CITY AND BOROUGH OF WRANGELL
Wrangell Water Treatment Plant Project

Addendum No. 3
July 12, 2023
(31 pages)

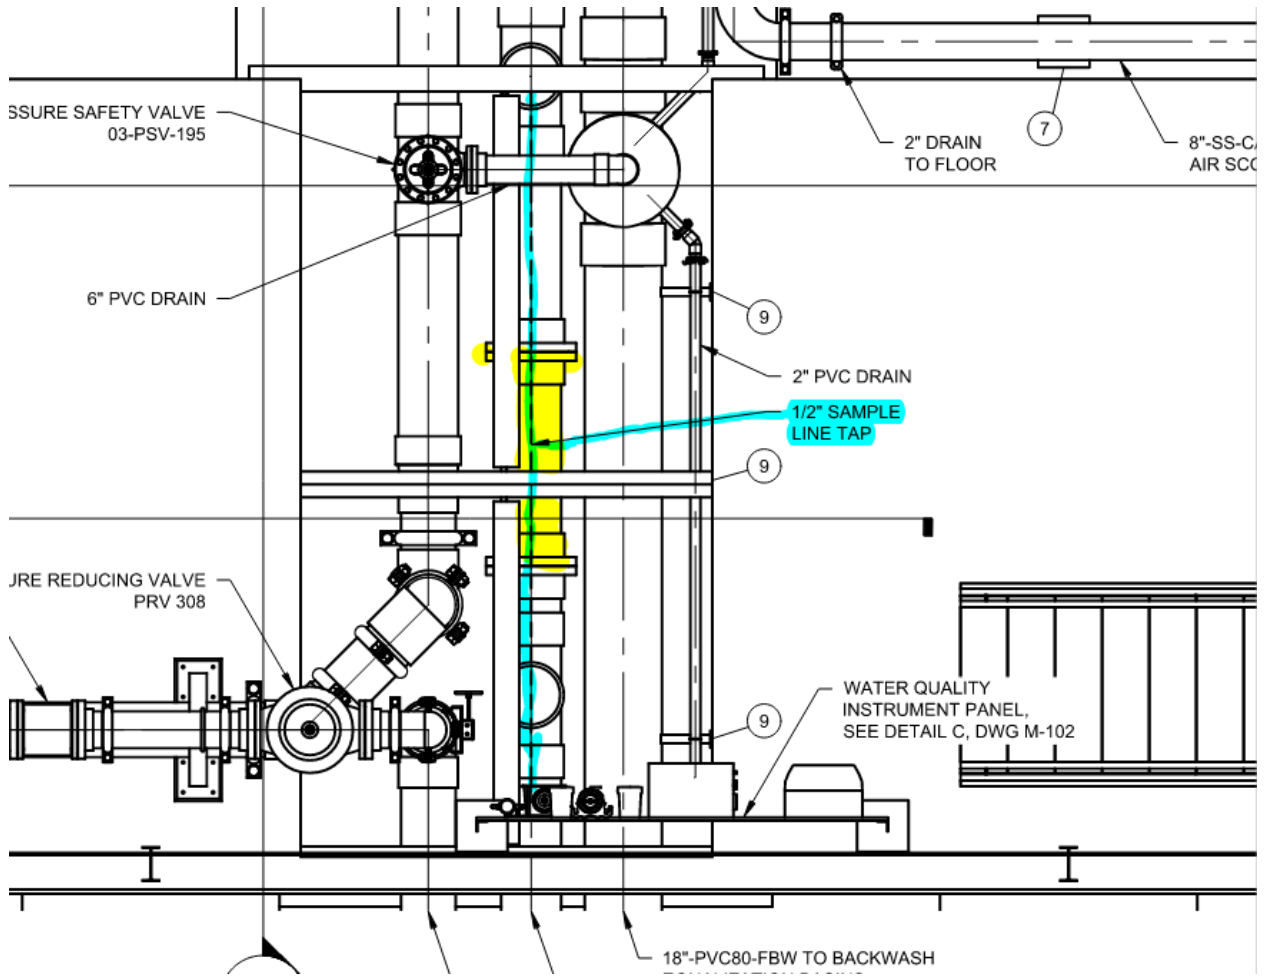
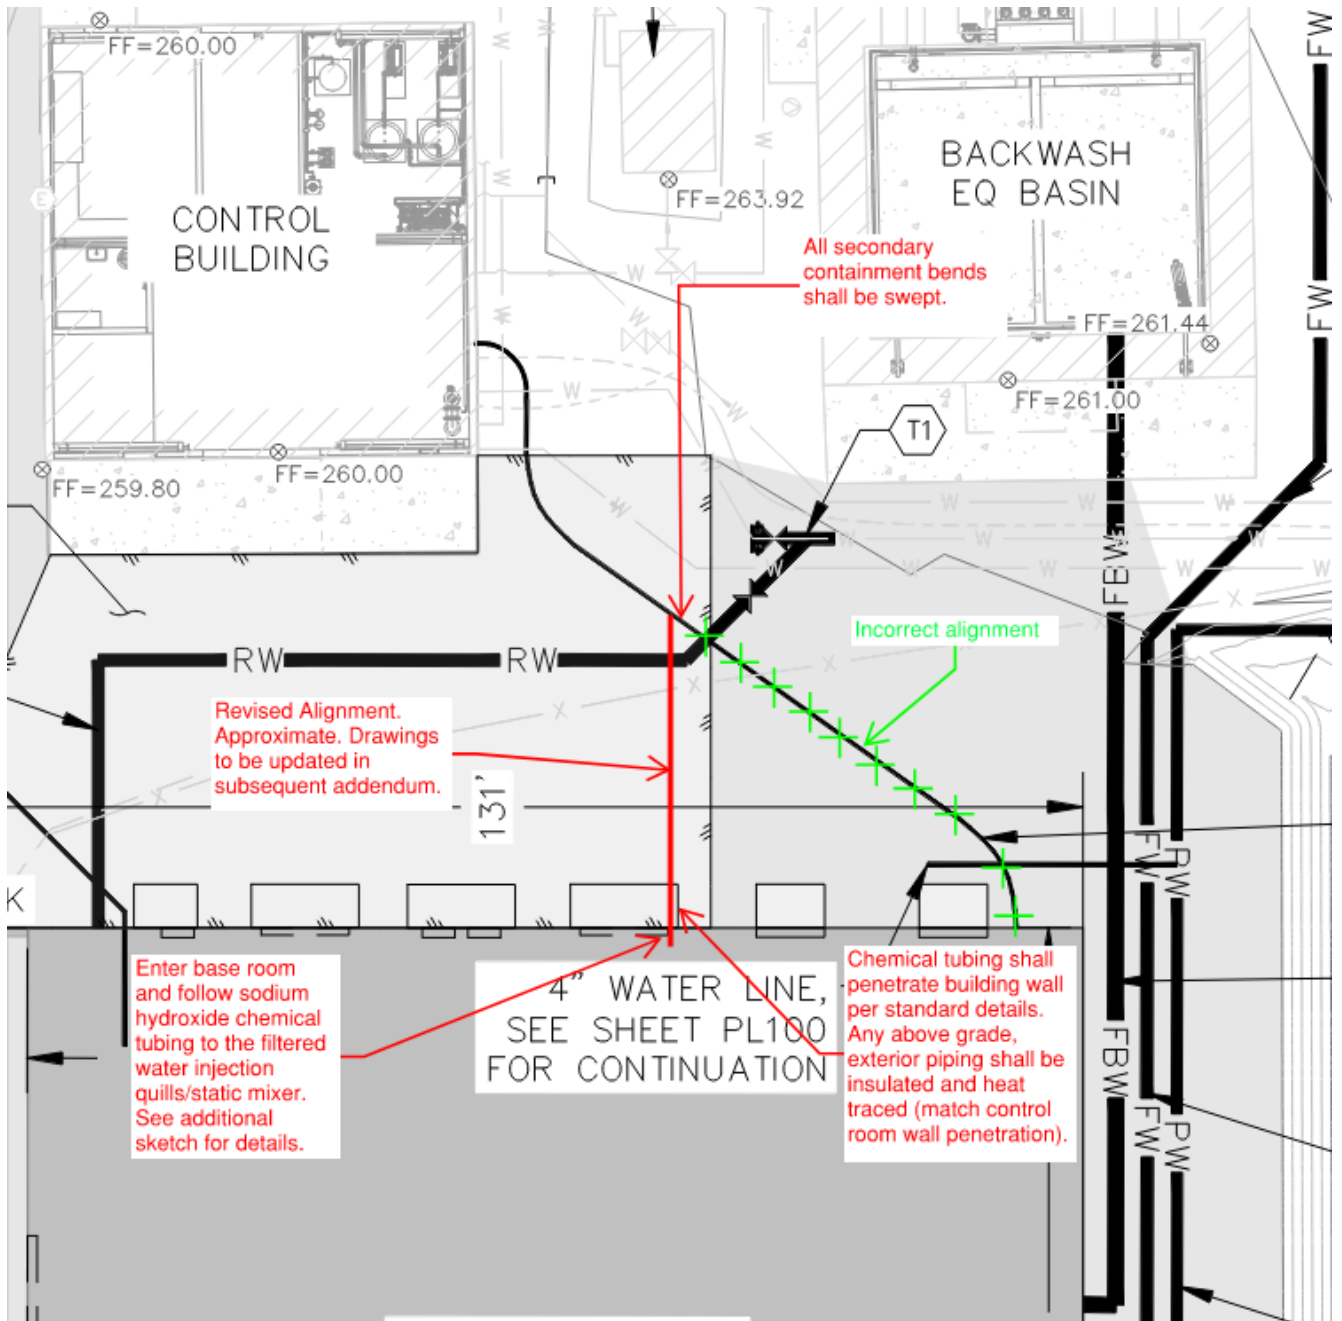
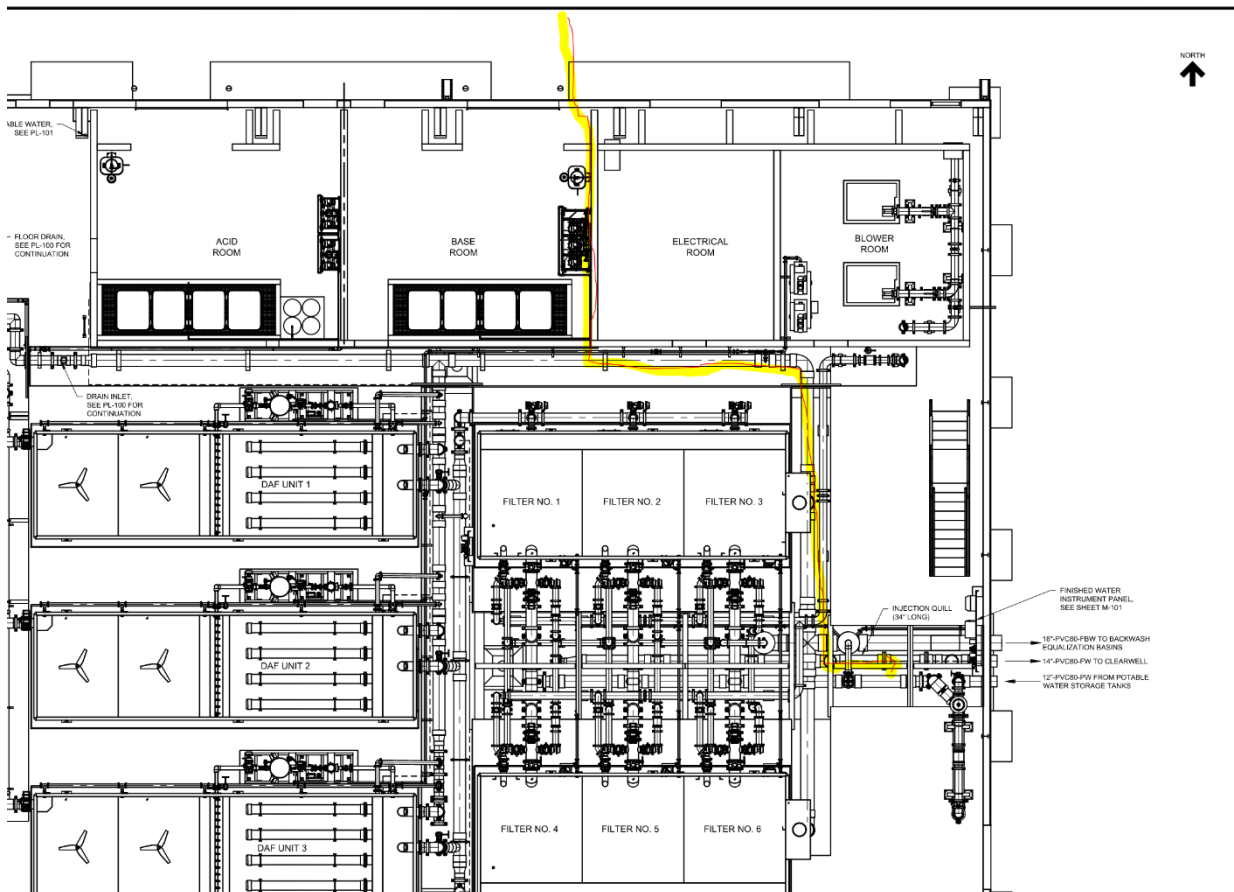
- a) Drawing PI-17 indicates static mixer SM-401 is installed in the 14" FW just after the chemical injection quills and before the sample tap to the FW instrument panel where the FW leaves the new WTP. Please indicate where this static mixer is located on the M drawings. Is it between the two "upright tees" on M-300 and M-301? Also, drawing C-104 illustrates the yard piping path for the OSHG chemical piping from the Control Building to the Blower Room of the new WTP. What is the intended path within the new WTP? The piping is not shown on the M drawings that conforms to the PI drawings. Are the "upright tees" meant to portray the three chemical injection quills in one and the sample tap in the other?

- a) The yellow highlighted section in the figure below is the static mixer on sheet M-300. This is not to be confused with the 1/2" sample line tap where the arrow is indicating. All chemistries should be able to route into the static mixer's pre-constructed openings for chemical injectors. The tee in front of the mixer is where the sample tap line comes off as well as the tee after the mixer. The tee in front of the mixer can be found on drawing PI-16.

The OSHG line routes through the "Base" room instead, noted in the picture above, and follows the path to injection as shown in the picture below.

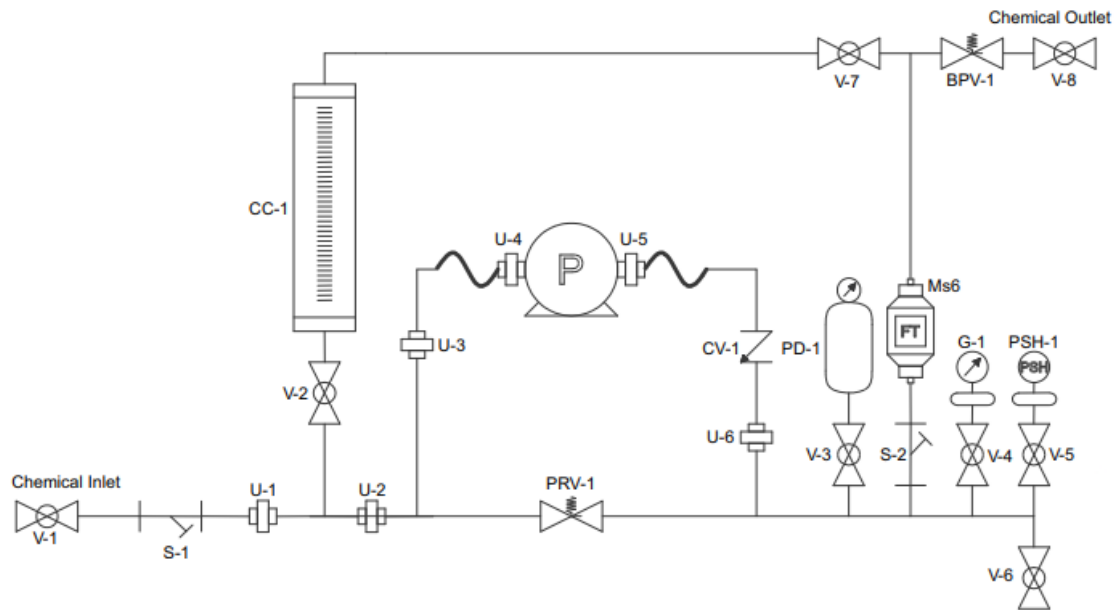
- c) Drawings PI-24 and PI-25 have a peculiar piping arrangement to the top of the calibration columns. This is never done with calibration columns and the correct piping route should come down and tee in under the calibration columns, above HV-543 and HV-573 respectively. Please clarify.

c) The duplex peristaltic pump skids detailed on PI-24 and PI-25 are drawn per the specified equipment vendors equipment data sheets. See photo (to right) of specified vendor's piping arrangement and a snippet from the user manual. The calibration column should include a vent or be open to the atmosphere allow the air in the column to vent while it is filling. In some instances, the metering pumps are located above the chemical drums, so the calibration column cannot be filled by gravity off of the chemical drum level. Instead, the column must be filled with the pumps, as described in the snippet below.

GROUND FLOOR PLAN
 SCALE: 1/8" = 1'-0"

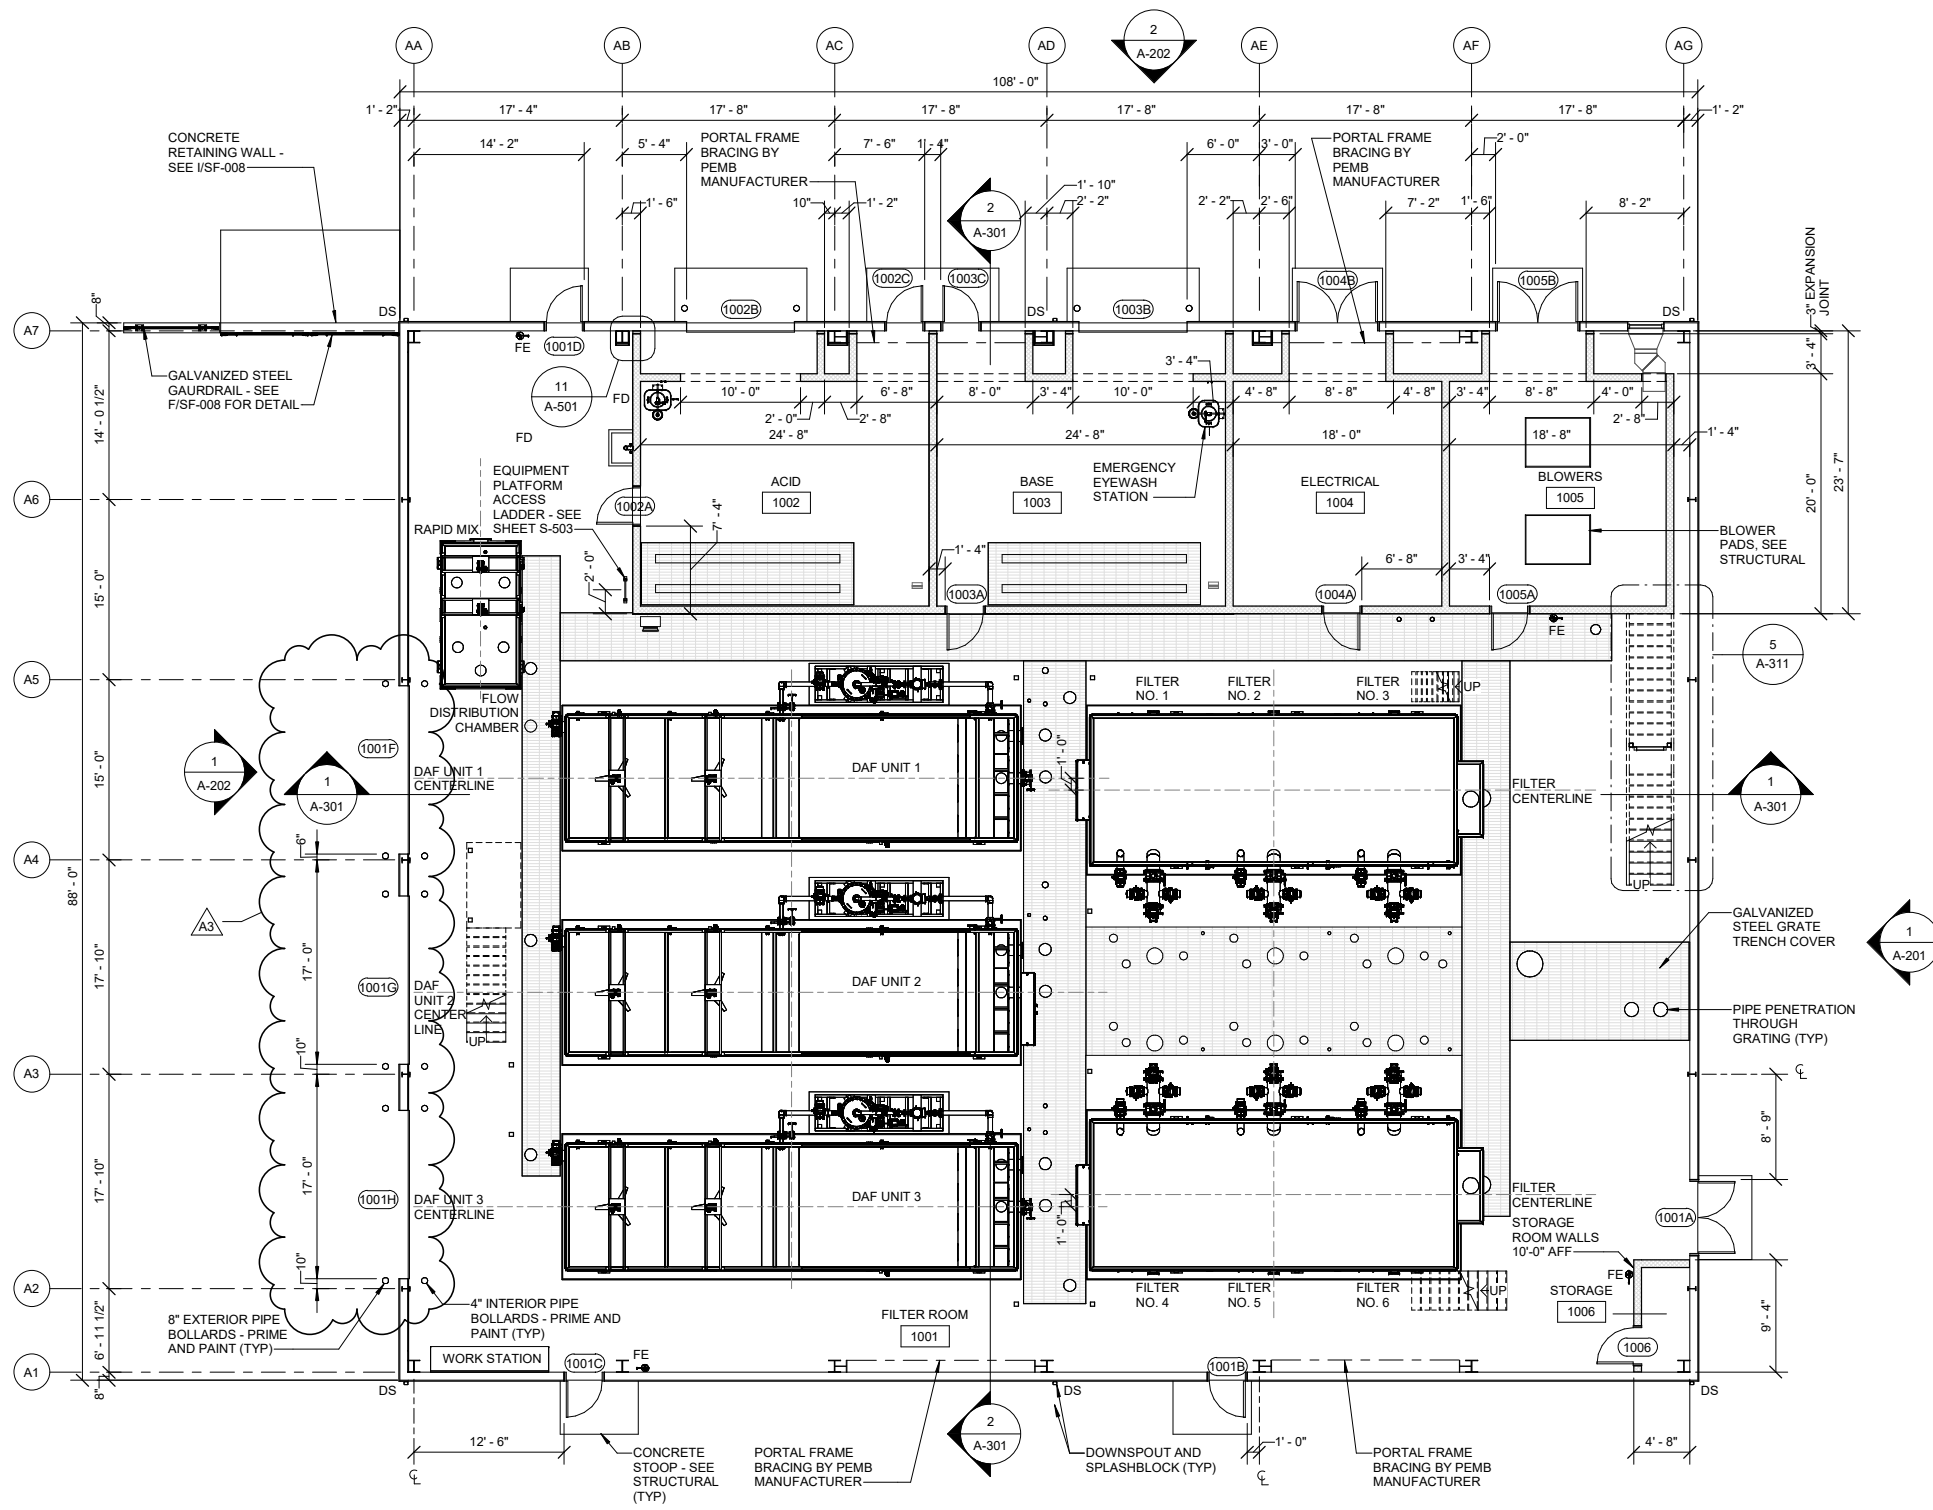
- b) The widest AWC shipped equipment is the filter trains which are a shipping maximum 13' 9" wide and a maximum 10' 8-1/2" high per AWC drawing 17805-PI-GAD-310. The tallest AWC shipped equipment is the DAF tanks which are a shipping maximum height of 12' 1" per AWC drawing 17805-PI-GAD-200. Drawing A-601 in the Large Door Schedule specifies doors 1001 F/G/H as 12' wide and 14' high. Is it possible that the door sizes were meant to be 14' wide and 14' high? Please clarify.

- b) Door 1001F, 1001G, 1001H will be increased to 14'-0" W x 14'-0" H. See Attachment 1 for revised sheets A-101 and A-601.
